PROPOSED 5th floor: PLANT ROOM FLOOR PLAN

scope related to 'Planning application to vary a Condition of Parent Application'

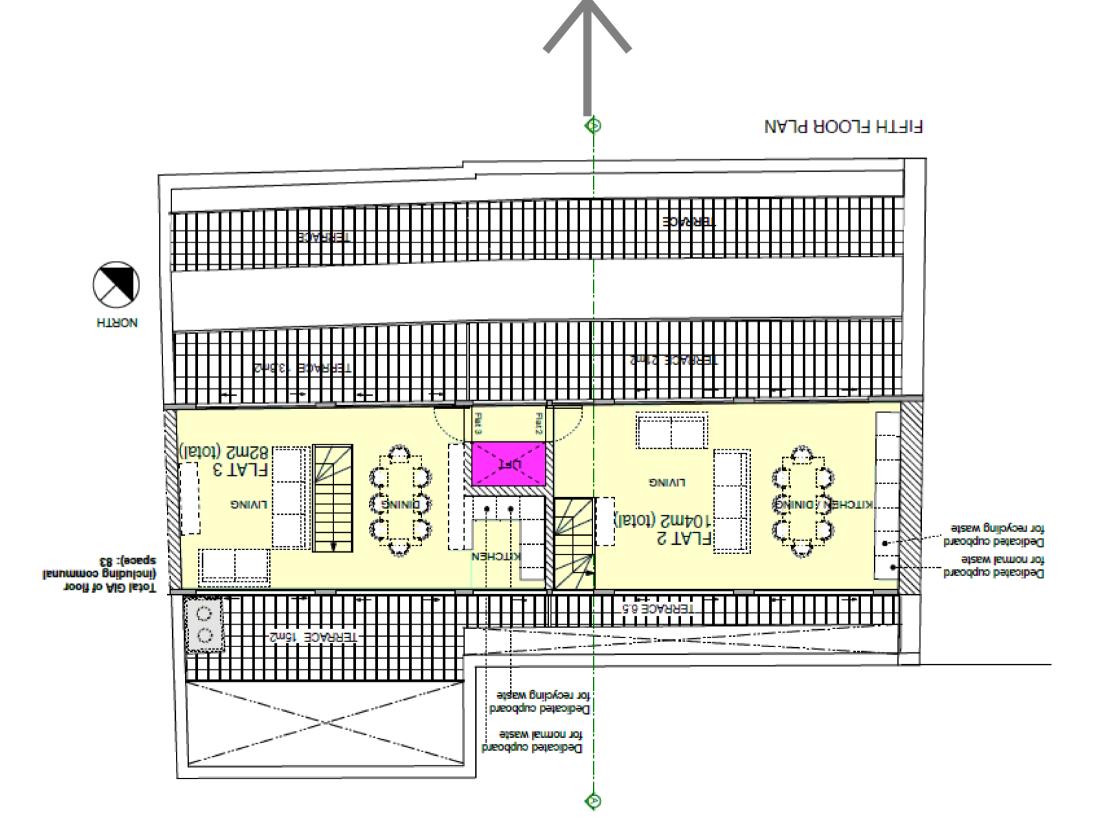
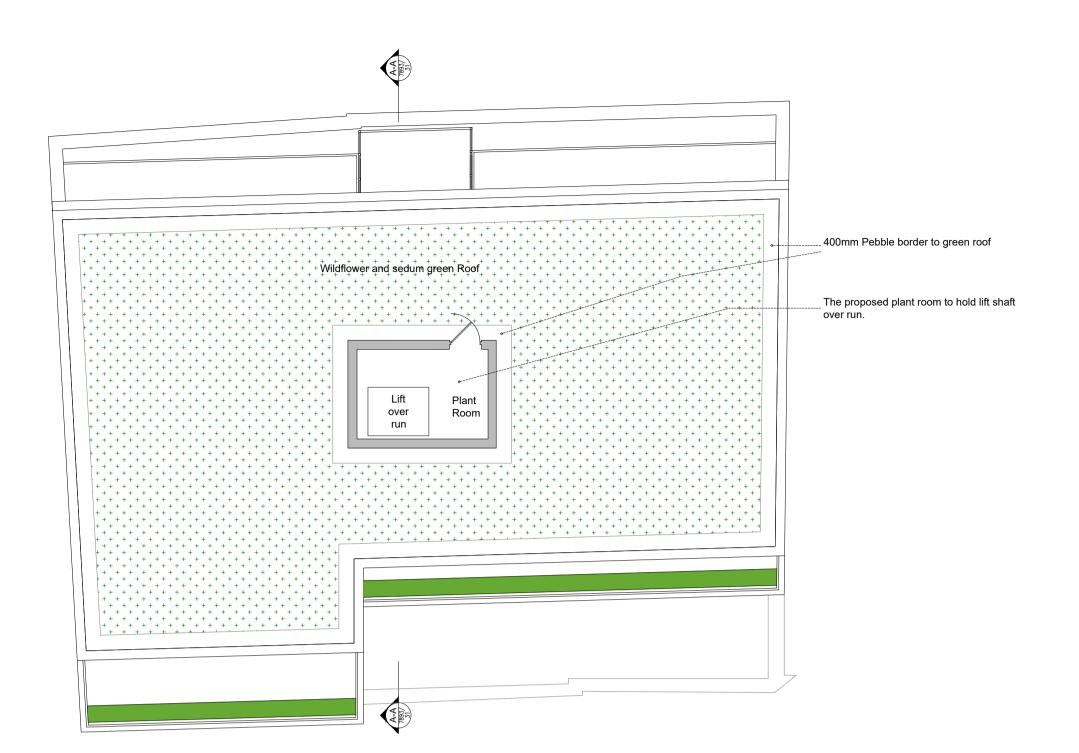
- plant room enlarged by 4.5sqm, modular green roof added
- roof mounted plant (condensing units) location rationalised within an acoustic enclosure
- proposed plan within the previously approved two storey scheme below
